**PSE&G** Public Service  
Electric and Gas  
Company

August 20, 1984

HOPE CREEK GENERATING STATION  
DOCKET NO. 50-354  
DRAFT SAFETY EVALUATION REPORT  
OPEN ITEM STATUS

Attachment 1 is a current list which provides a status of the open items identified in Section 1.7 of the Draft Safety Evaluation Report (SER). Items identified as "complete" are those for which PSE&G has provided responses and no confirmation of status has been received from the staff. We will consider these items closed unless notified otherwise. In order to permit timely resolution of items identified as "complete" which may not be resolved to the staff's satisfaction, please provide a specific description of the issue which remains to be resolved.

Fig. 6.3-5P

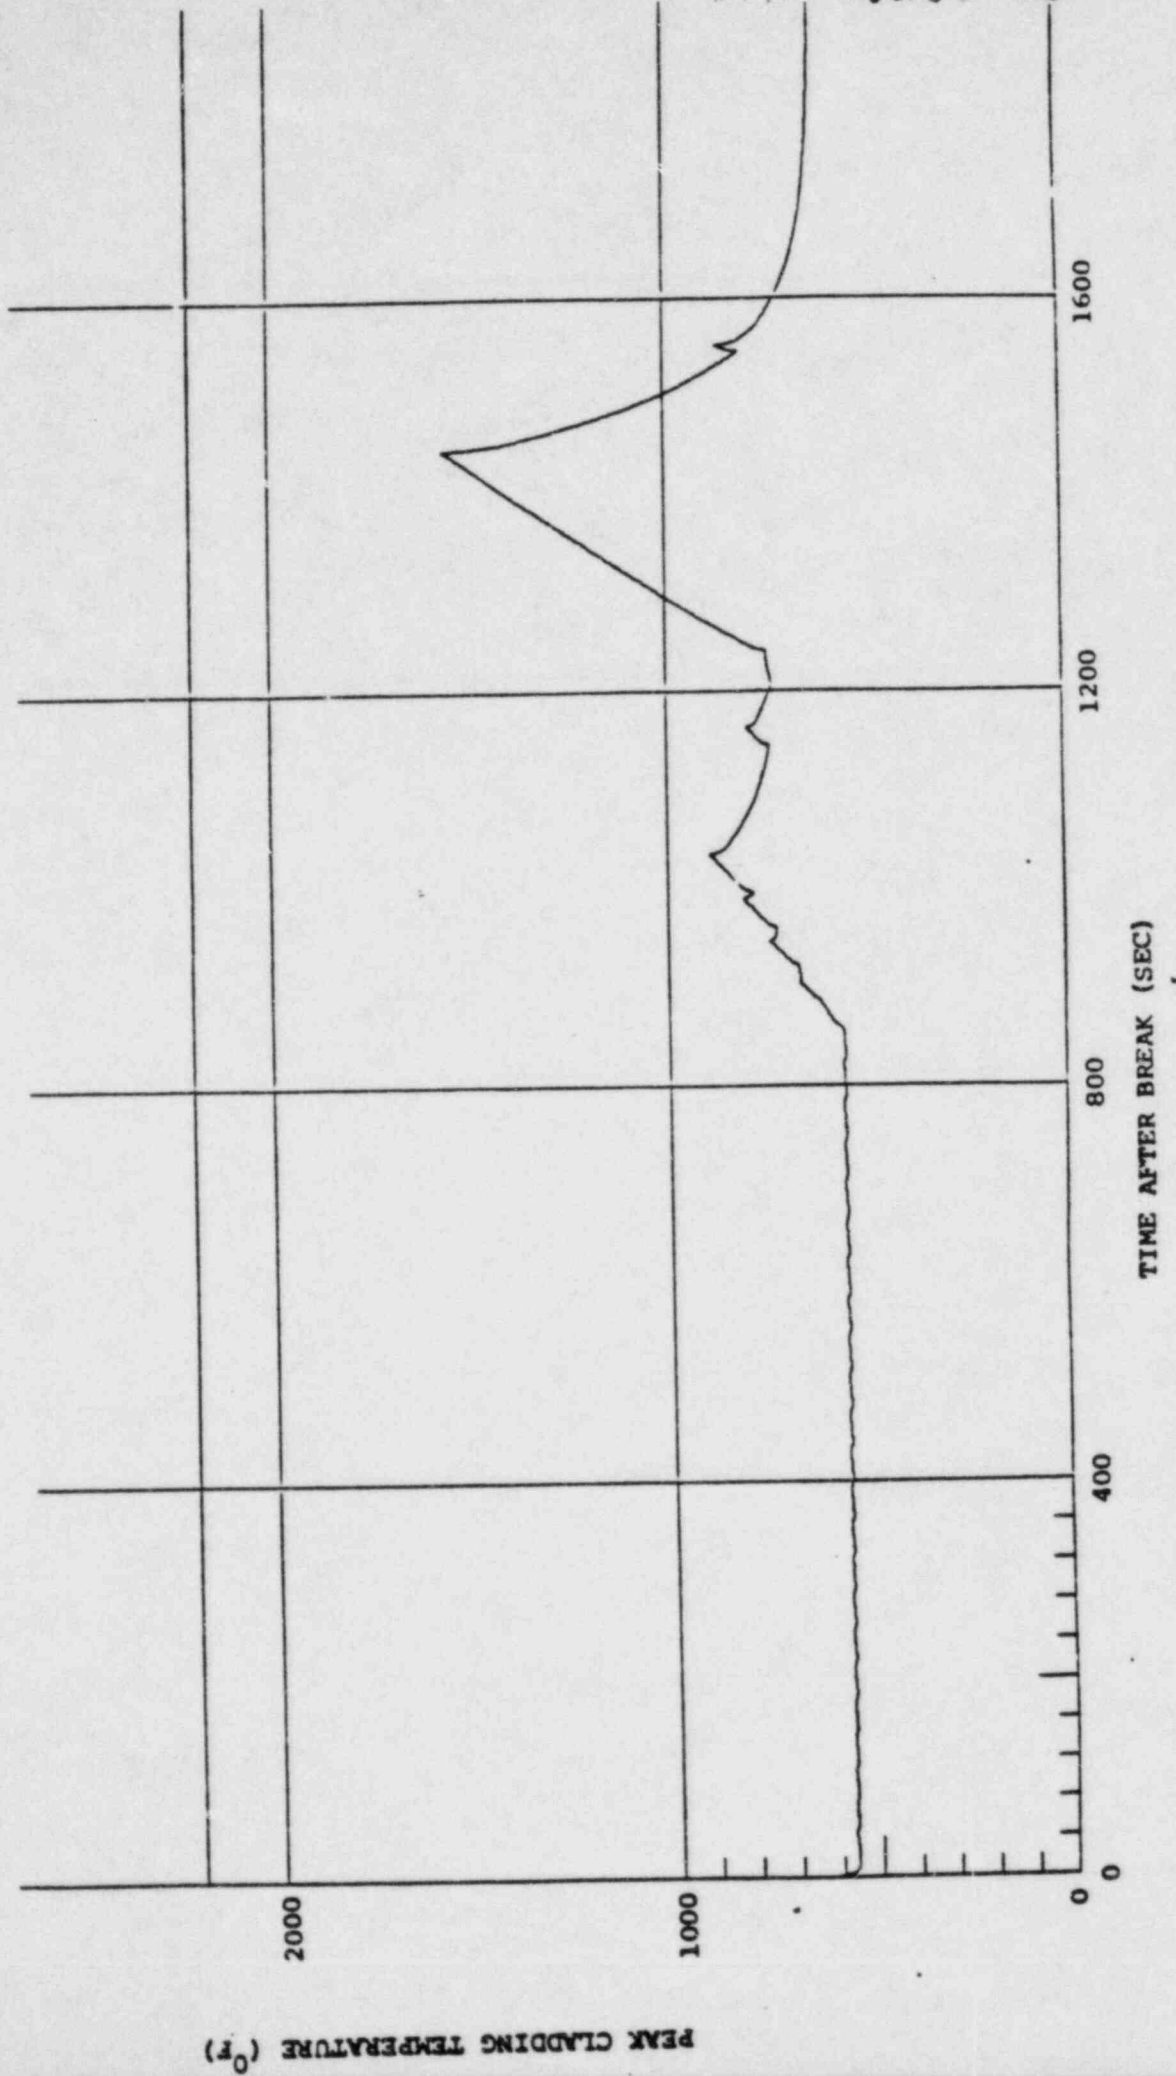
*\* Replace with attached figure*

**PORTION OF FIGURE 7.3-3**

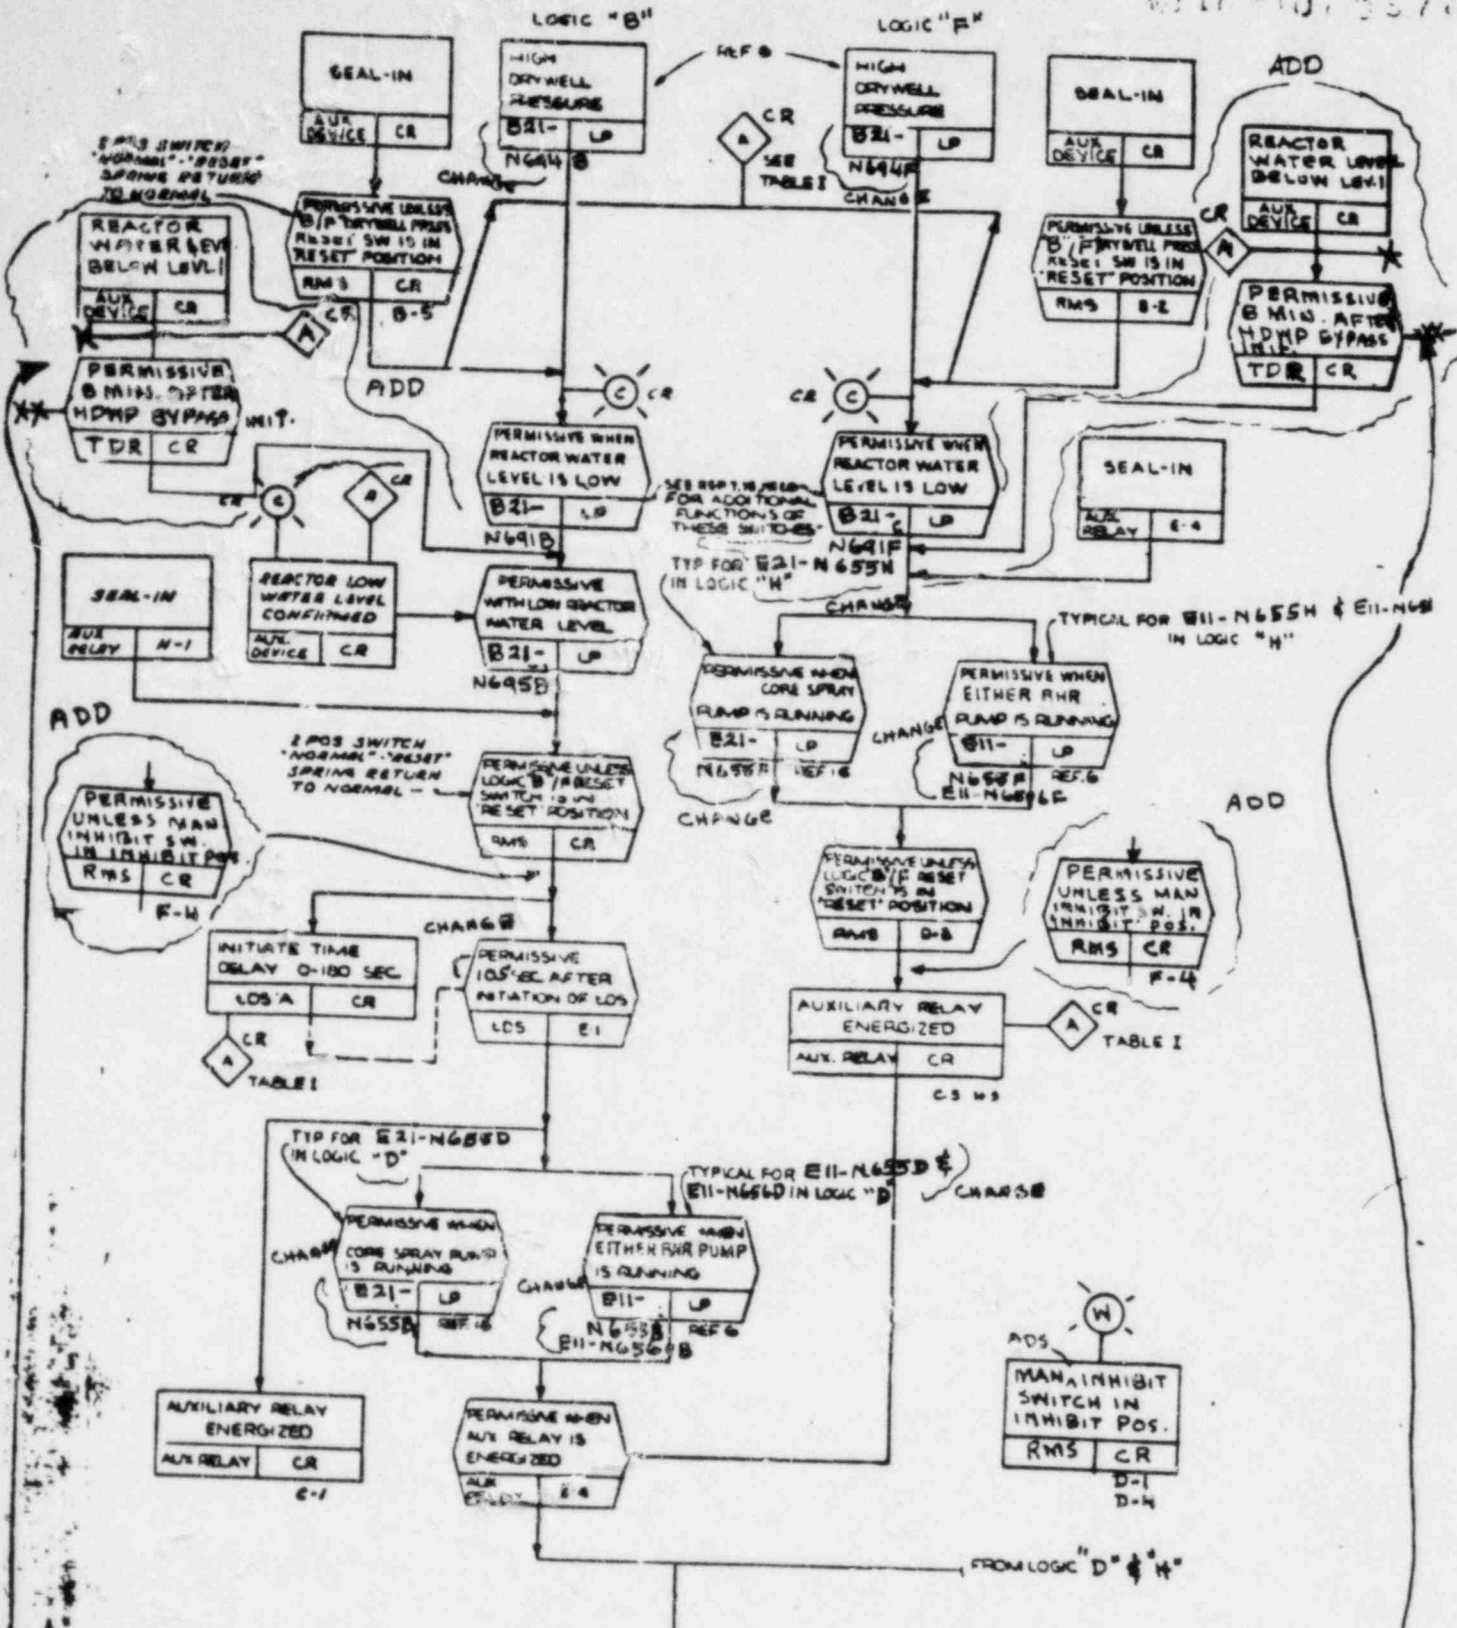
To prevent inadvertent actuation of the ADS, two channels of logic for each ADS trip system (B and D) are used. Both channels must function to actuate an ADS trip system. Refer to Figure 7.3-3 for a schematic representation of the ADS initiation logic.
